BID ADDENDUM NO. 3

Date of Addendum: January 18, 2024
Issued for Bid Date: December 18, 2022
Client Name: Eastchester Union Free School District
Project Name: 2022 Capital Bond Project, Phase 3
SED Project No.: Anne Hutchinson Elementary School: 66-03-01-03-0-001-023
Eastchester Middle / High School: 66-03-01-03-0-003-031
MEMASI Project No.: 102-2301
Contracts: Contract No. 1 – General Construction (GC)
Contract No. 2 – Mechanical Construction (MC)
Contract No. 3 – Electrical Construction (EC)
Contract No. 4 – Plumbing Construction (PC)

GENERAL NOTES, RTU FRAMING PLAN & DETAILS

MSHS S-100

5 AREA A DUNNAGE FRAMING ELEVATION SCALE: N.T.S.

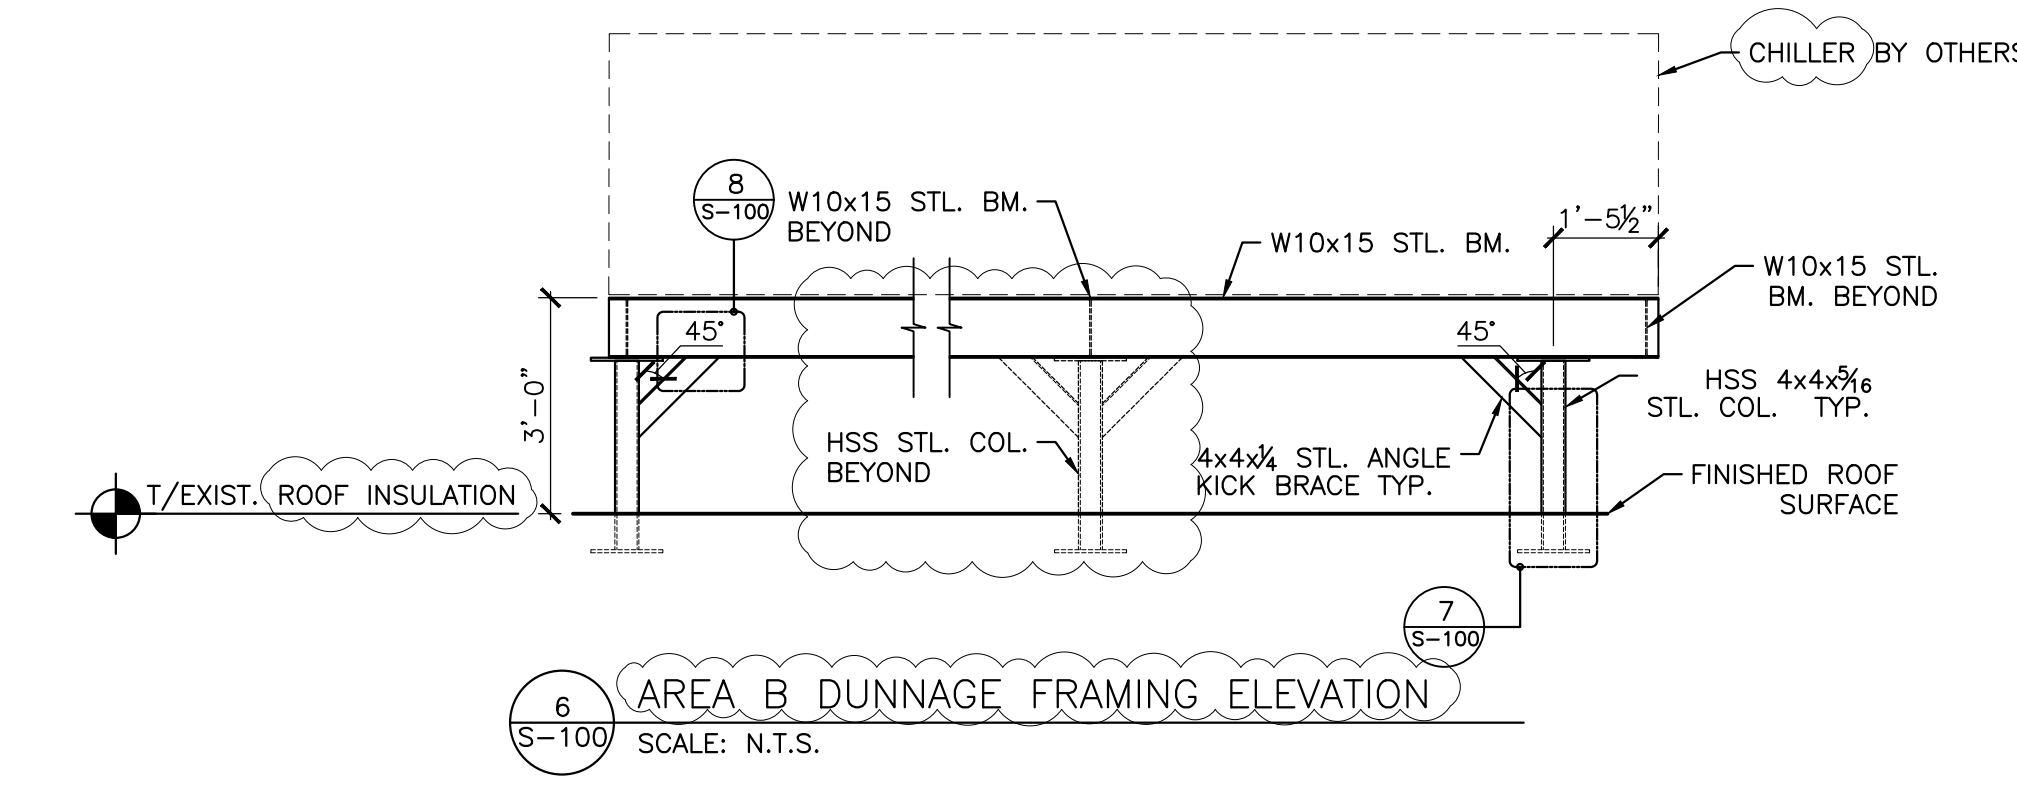
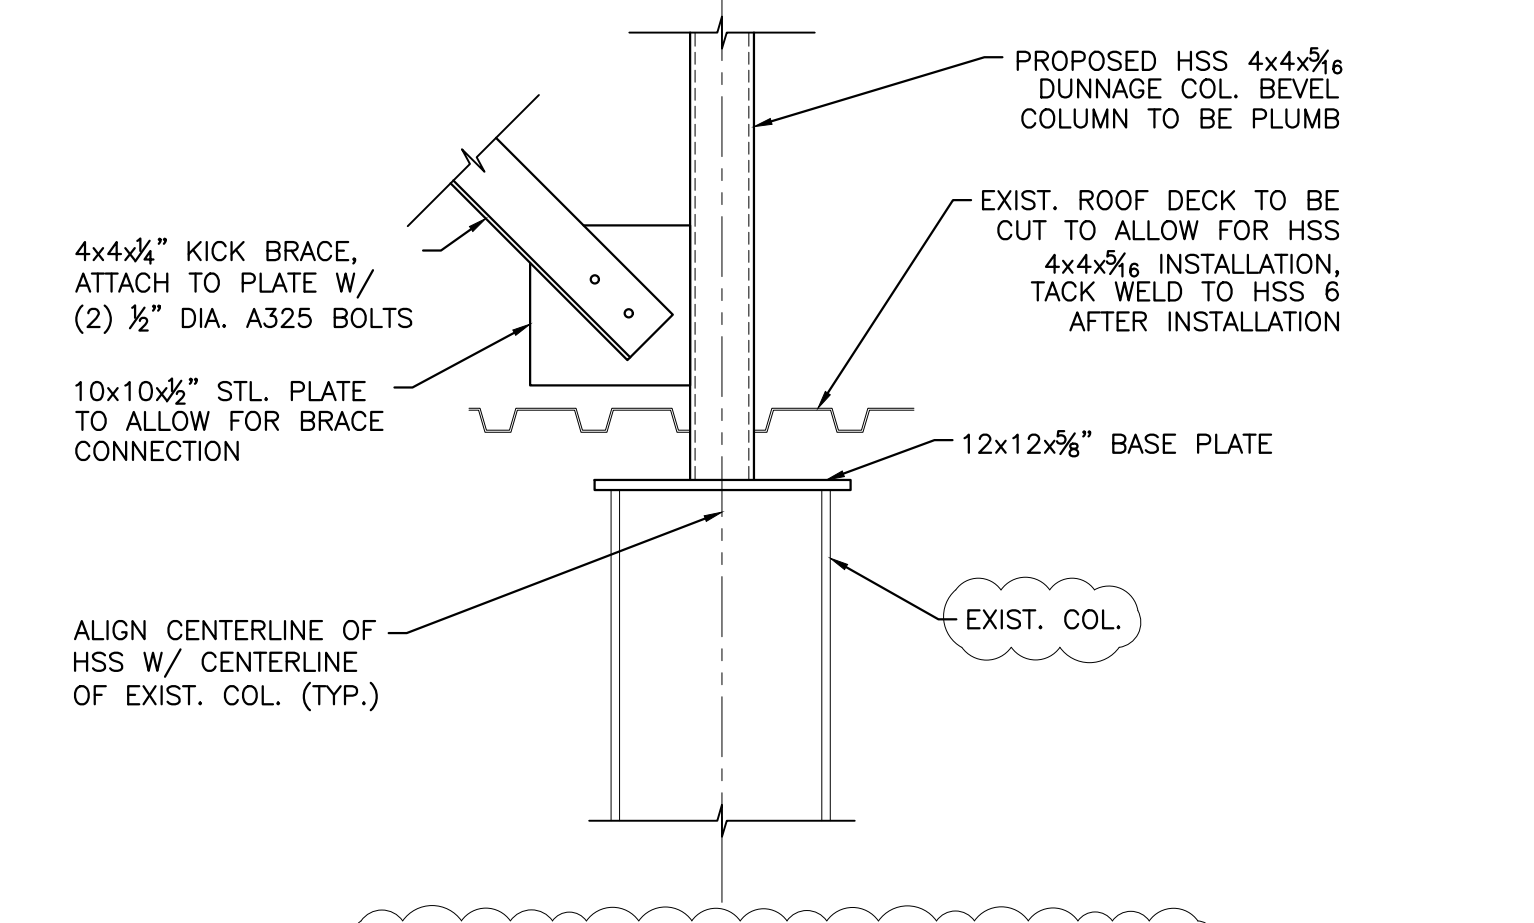
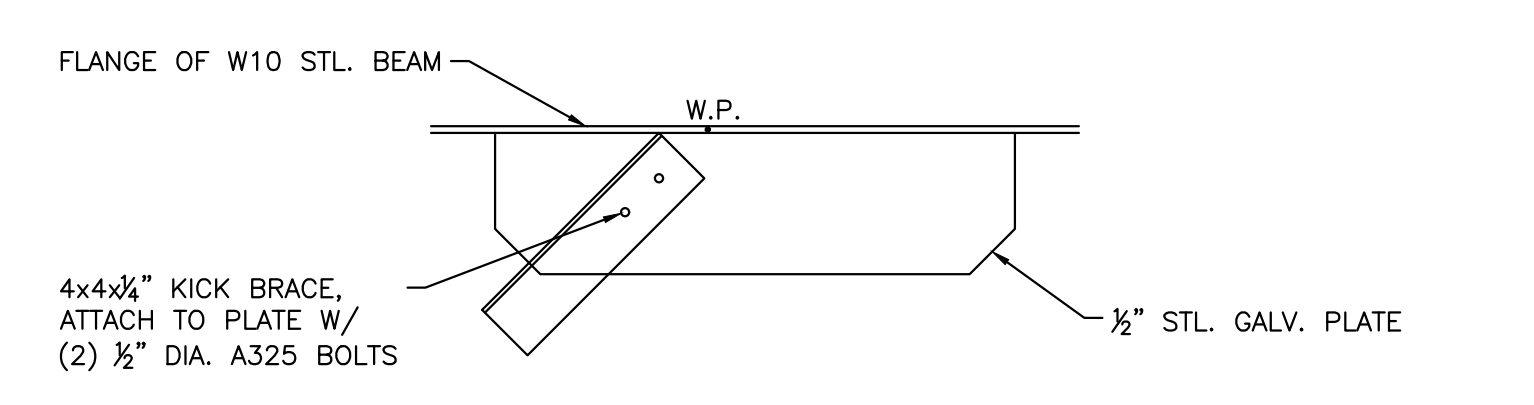
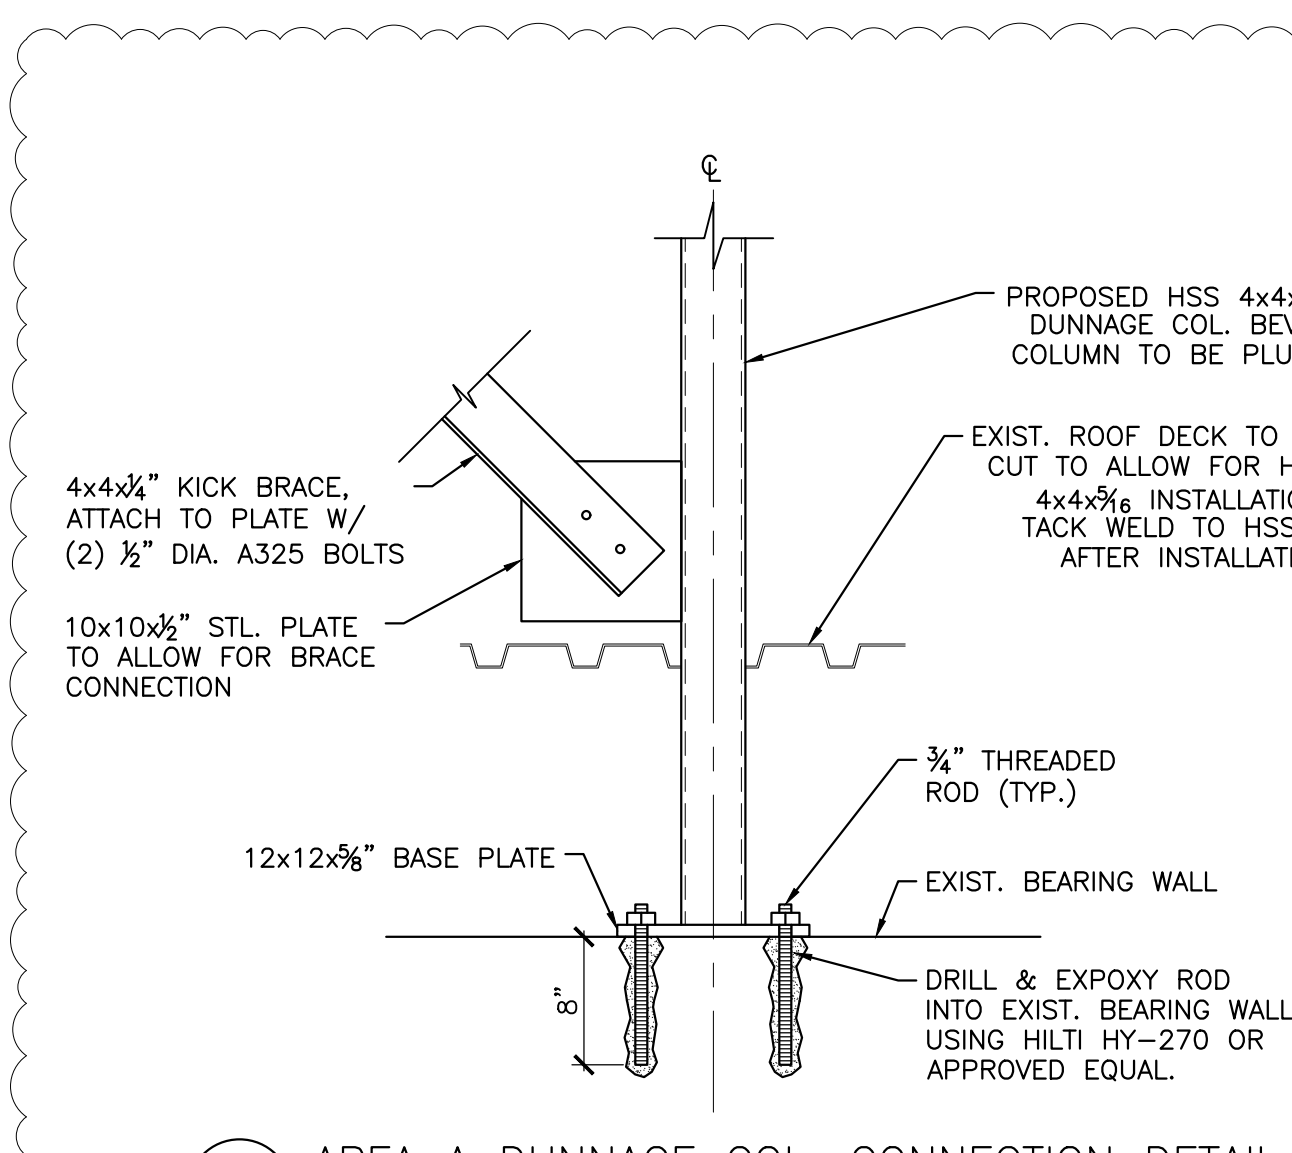
- a. Details were renumbered and page locations were corrected.
- b. For 1/S-100, Note 3 and 5 were deleted. For 2/S-100, Note 2 was deleted. For 3/S-100, notes 2,4,5, and 6 were deleted.
- c. For 1/S-100 and 2/S-100, “RTU” was changed to “CHILLER”, Notes 1 and 2 were corrected and Notes 6 and 7 were added to accommodate MEP openings.
- d. For 3/S-100, Notes 1 was corrected and Notes 3 and 4 were added to accommodate MEP

- openings.
 - e. 5/S-100 was added to clarify the dunnage design for Area A. Title for 6/S-100 was changed to distinguish from 5/S-100
 - f. 6/S-100 was edited for clarity.

- g. 9/S-100 was added to show the bearing plate to bearing wall connection for Area A dunnage that was previously not defined. Title for 7/S-100 was changed to distinguish from 9/S-100.

STRUCTURAL
SLEEVE

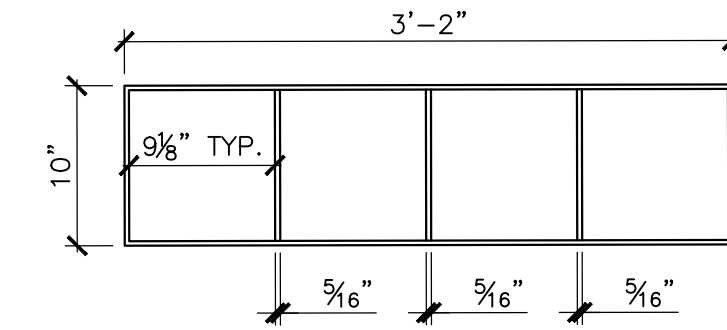
2. **MSHS S-101 – STRUCTURAL SLEEVE**
 - a. Structural sleeves were resized to match sizes on MEP plans.
 3. **MSHS MD100-A – MECHANICAL DEMOLITION PART PLAN – BASEMENT – AREA A**

**MECHANICAL PART
PLAN - 2ND FLOOR -
AREA C**

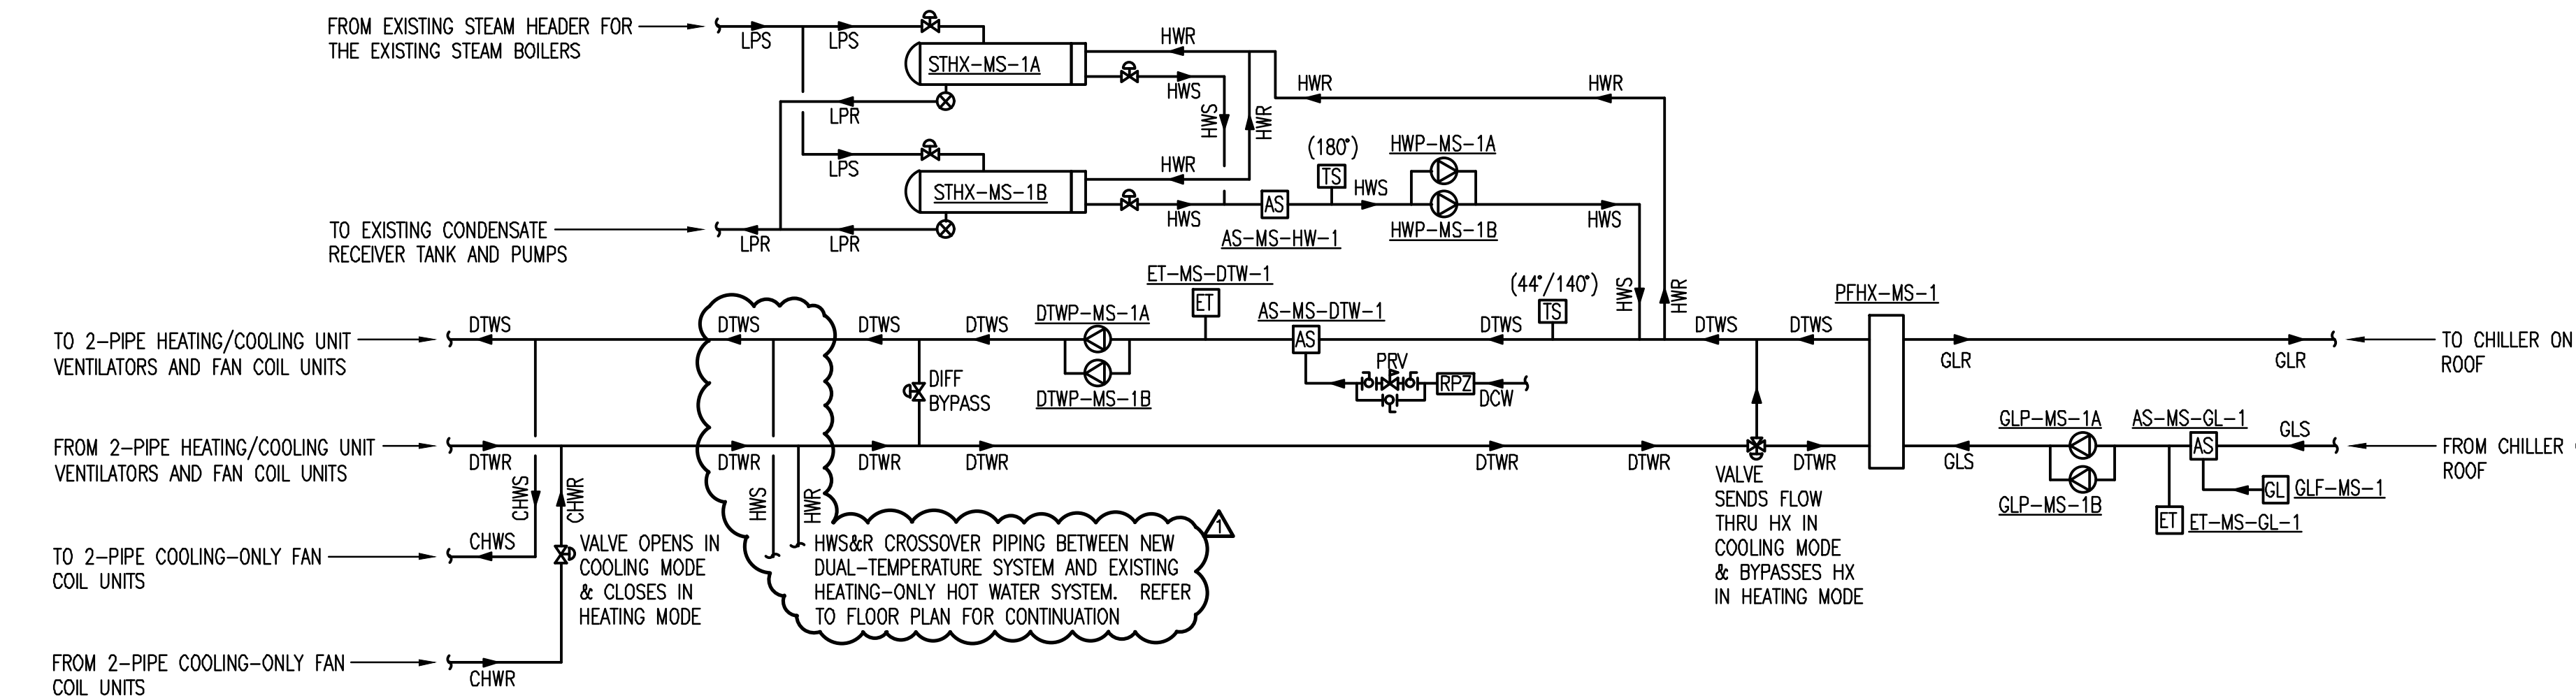
7. **MSHS M102-C – MECHANICAL PART PLAN – 2ND FLOOR – AREA C**
 - a. The drawing was revised to indicate modified duct and pipe routing in the gymnasium mechanical penthouse.
